HISTORIC AND DESIGN REVIEW COMMISSION

HDRC CASE NO: 2021-200
ADDRESS: 233 N MESQUITE ST
LEGAL DESCRIPTION: NCB 582 BLK 9 LOT 5&6
ZONING: C-3, H
CITY COUNCIL DIST.: 2
DISTRICT: Dignowity Hill Historic District
APPLICANT: Cotton Estes
OWNER: Cotton Estes
TYPE OF WORK: Exterior modifications, rehabilitation
APPLICATION RECEIVED: April 16, 2021
60-DAY REVIEW: Not applicable due to City Council Emergency Orders
CASE MANAGER: Edward Hall

Industrial Renovation for Architecture Office & Carpentry Shop
Application for Historical COA 04.15.2021
Dignowity Hill Historic District

SITE PLAN & AREA
MAP

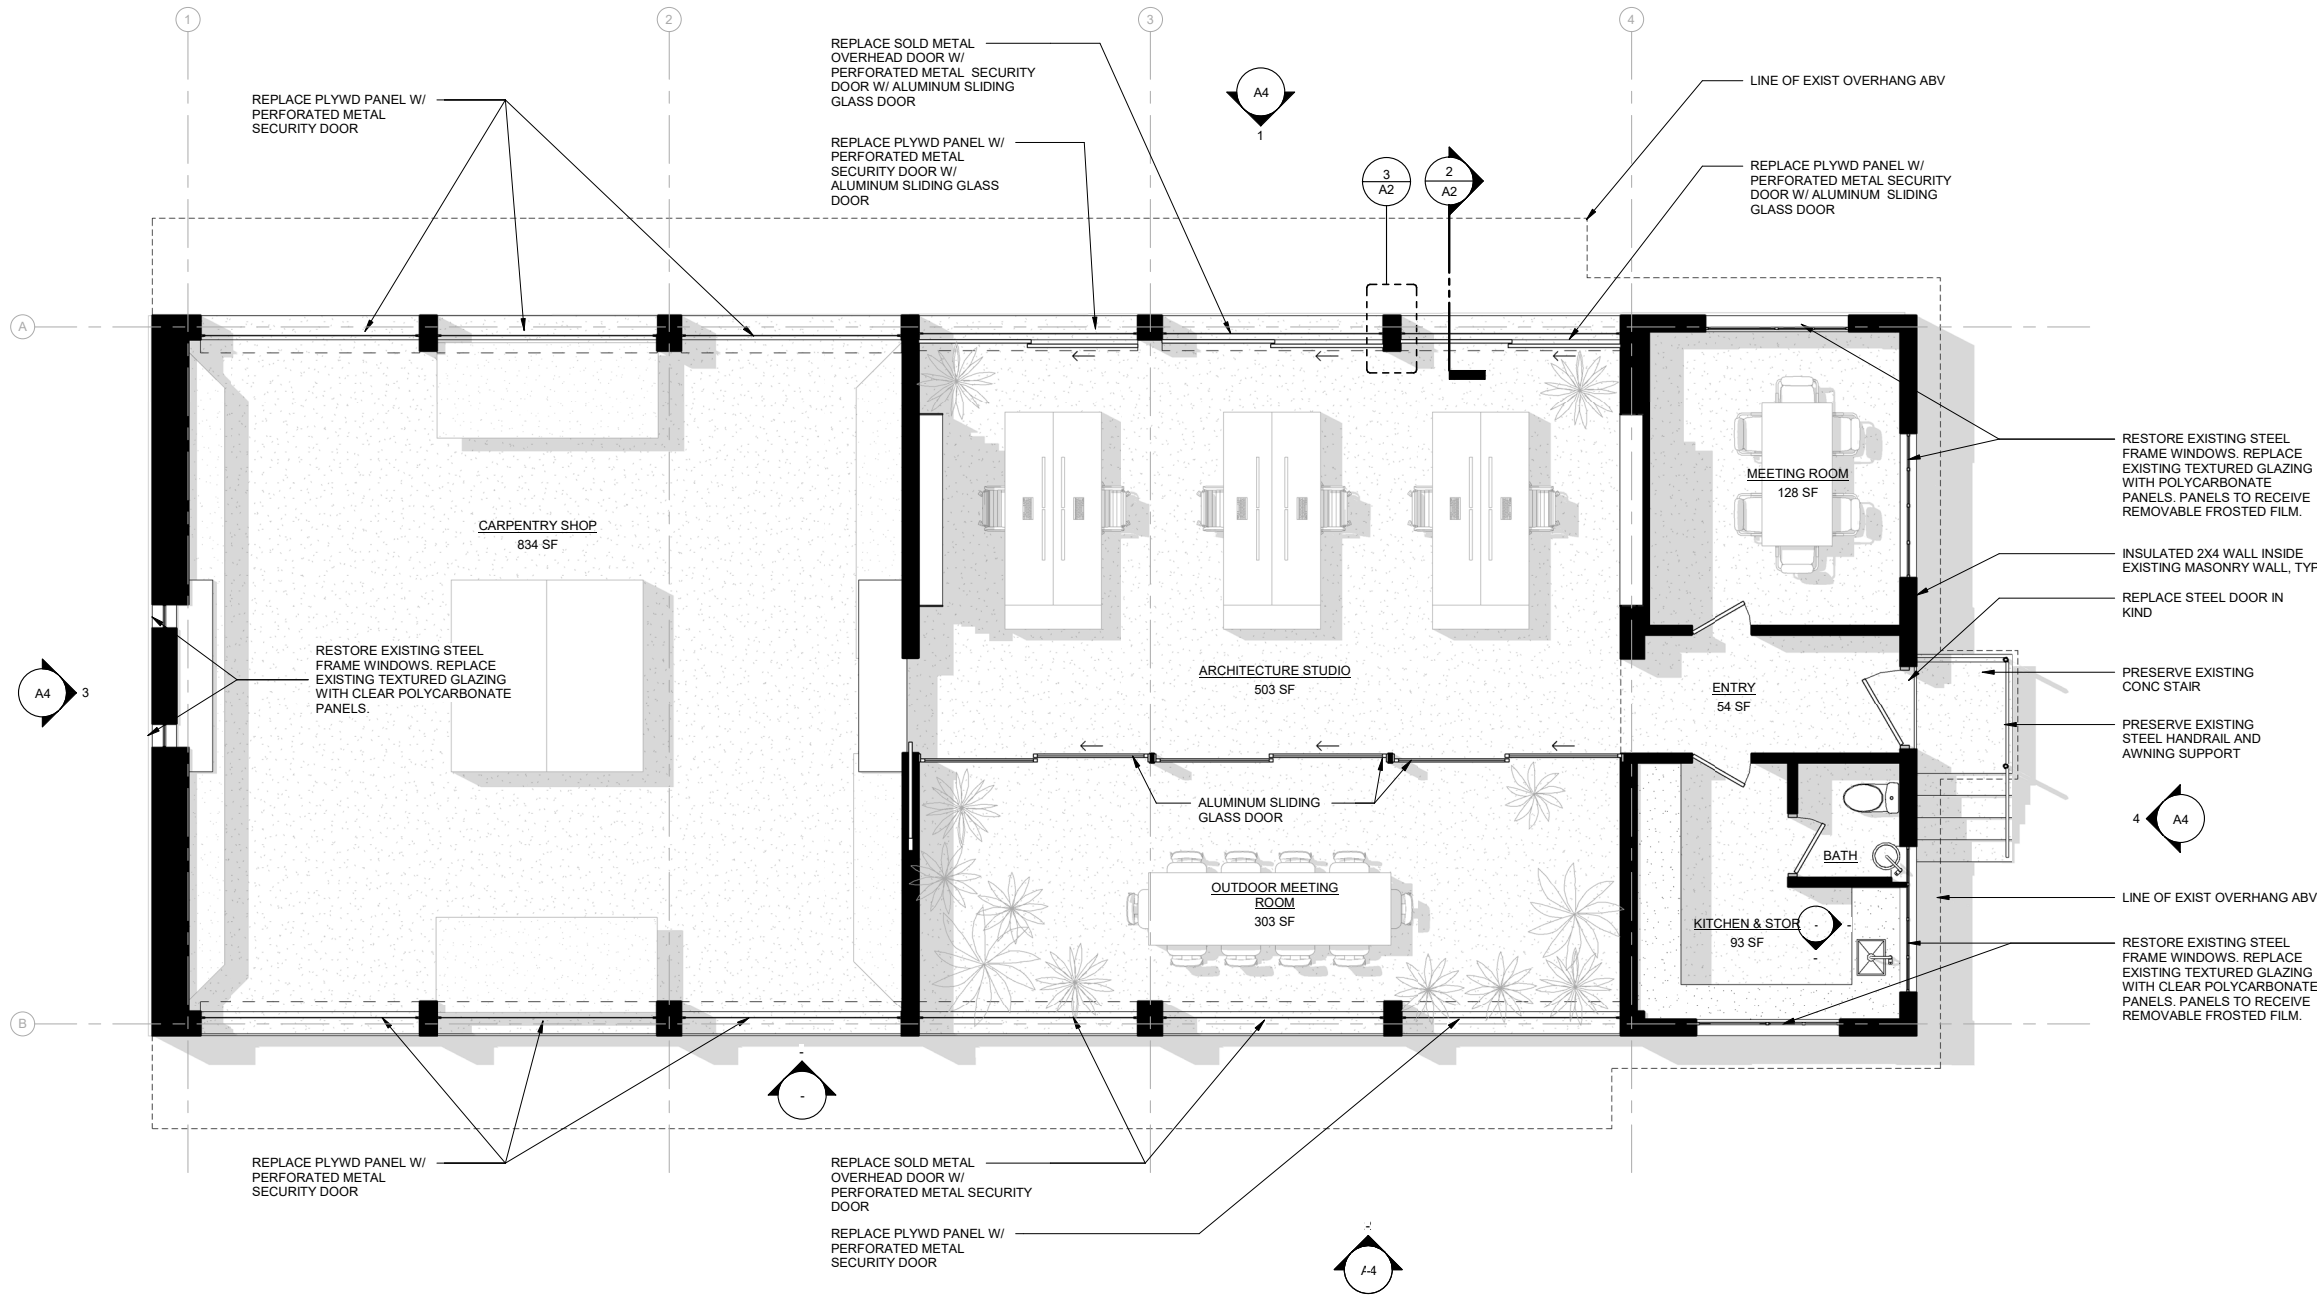
- e. REGRADING – The existing site features various mounds that were previously used as informal access ramps. The applicant has proposed to remove these and regrade the site and remove these. Staff finds this to be appropriate.

- f. REAR PARKING AND DRIVEWAY – Per the Guidelines for Site Elements 7.A.i., parking areas for nonresidential and mixed-use structures are to be placed at the rear of the site, behind primary structures to hide them from the public right-of-way. On corner lots, place parking areas behind the primary structure and set them back as far as possible from the side streets. Parking areas to the side of the primary structure are acceptable when location behind the structure is not feasible. The applicant has proposed to install a parking lot to feature parking for three (3) vehicles on the west side of the lot, adjacent to an existing parking location on the lot immediately adjacent to the west. The proposed parking lot will feature permeable pavement and will be accessed by a curbcut and driveway on E Crockett Street. The applicant has noted a general width of 9' – 6" for the proposed driveway, which will then widen into a loading area, paved with permeable paving. While this is atypical with driveways found within the district in residential context, staff finds the wider drive area to be appropriate at this location. Staff finds both the proposed parking location and driveway to be appropriate and consistent with the Guidelines; however, staff finds that the proposed parking area should be screened from view from the right of way on E Crockett. Landscaping materials are appropriate for screening.

- i. That all openings remain as they currently exist.
- ii. That all repair and maintenance work be done in-kind, with like materials.
- iii. That the proposed parking area be screened from view from the right of way on E Crockett. Landscaping materials are appropriate for screening.

1 NORTH
SCALE: 1/4" = 1'-0"

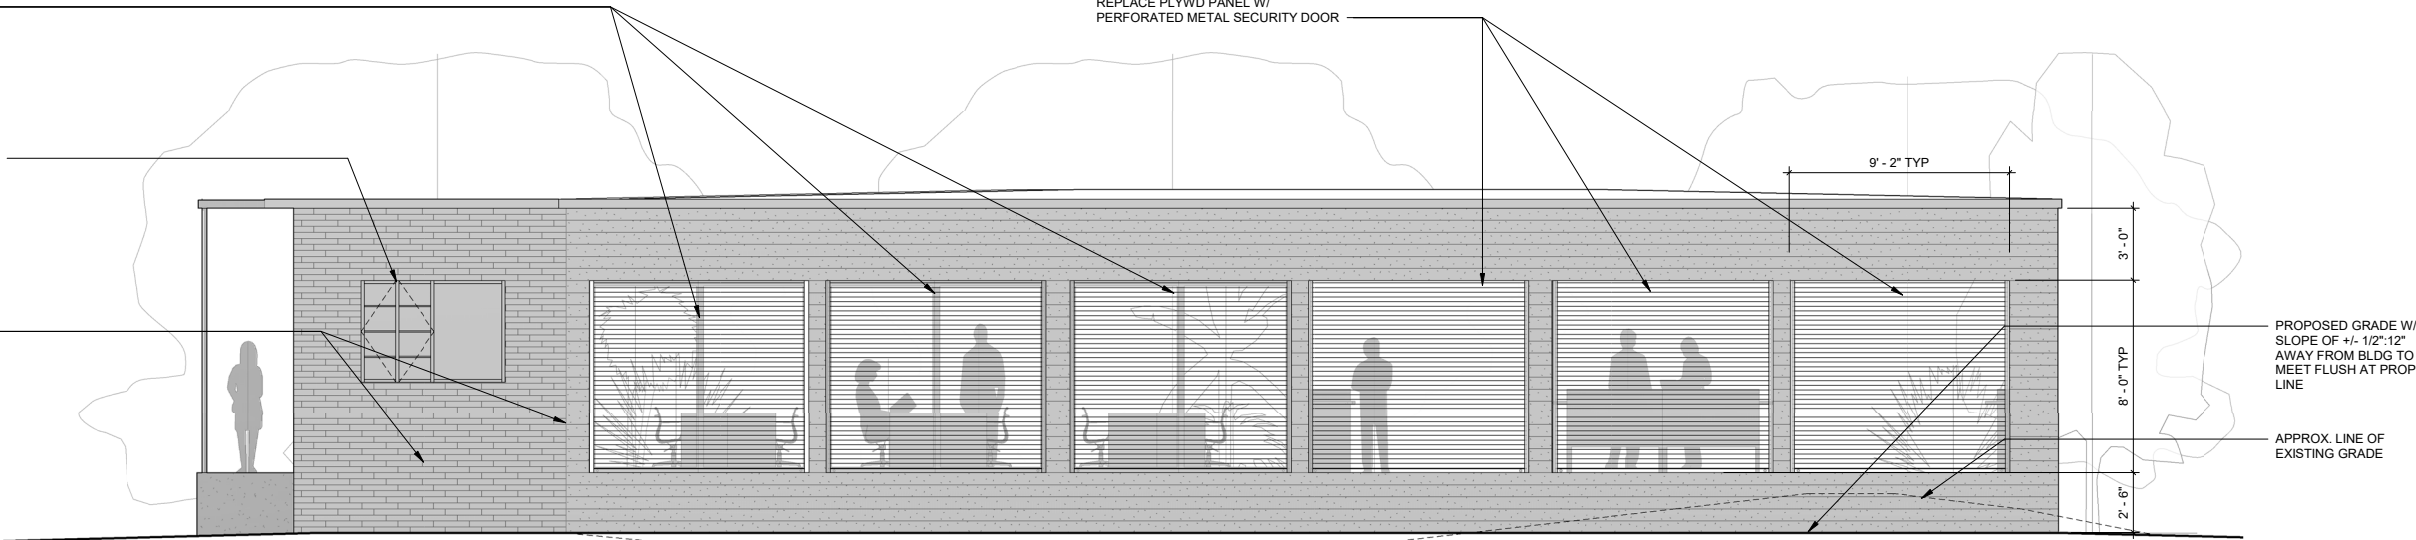
- b. GARAGE DOORS – The structure currently features twelve (12) garage door openings, three of which feature overhead garage doors. At this time, the applicant has proposed to install new, perforated metal garage doors in locations that previously featured overhead rolling garage doors. Additionally, the applicant has proposed to install sliding aluminum framed glass doors. Generally, given the industrial nature of the structure and the existing use of overhead rolling garage doors, staff finds the proposed installation of be appropriate.

- c. STEEL WINDOW REPAIR – The structure currently features six (6) existing windows openings that feature steel casement windows. The applicant has proposed to repair the existing, steel windows and install new glass to feature a clear, polycarbonate film. The interior of each glass pane will feature a frosted coating in lieu of the previously installed textured glazing. Staff finds the proposed repair to be appropriate.

- d. MASONRY REPAIR – The applicant has proposed to patch and repair the existing, masonry concrete as needed and apply a mineral based limewash to coat the masonry. Generally, staff finds this to be appropriate.
